DIPSTICK COMES UP SHORT

You're going to have a hard time checking the engine oil level on your howitzer or ammo carrier with replacement dipstick, NSN 6680-00-257-1396. It's a little too short for the job.

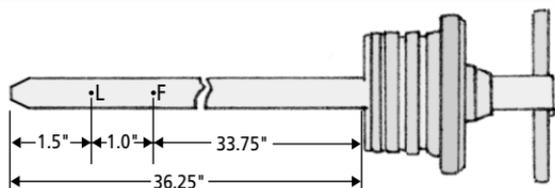
For models 7083-7391, 7083-7396, and 7083-7399, cut, bevel the edges and add markings like so:

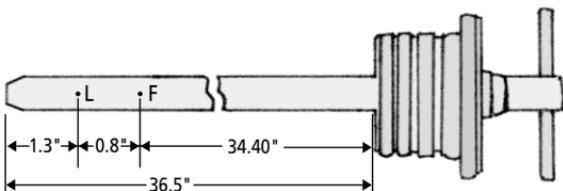
For models 7083-7395 and 7083-7398, cut, bevel the edges and add markings like this:
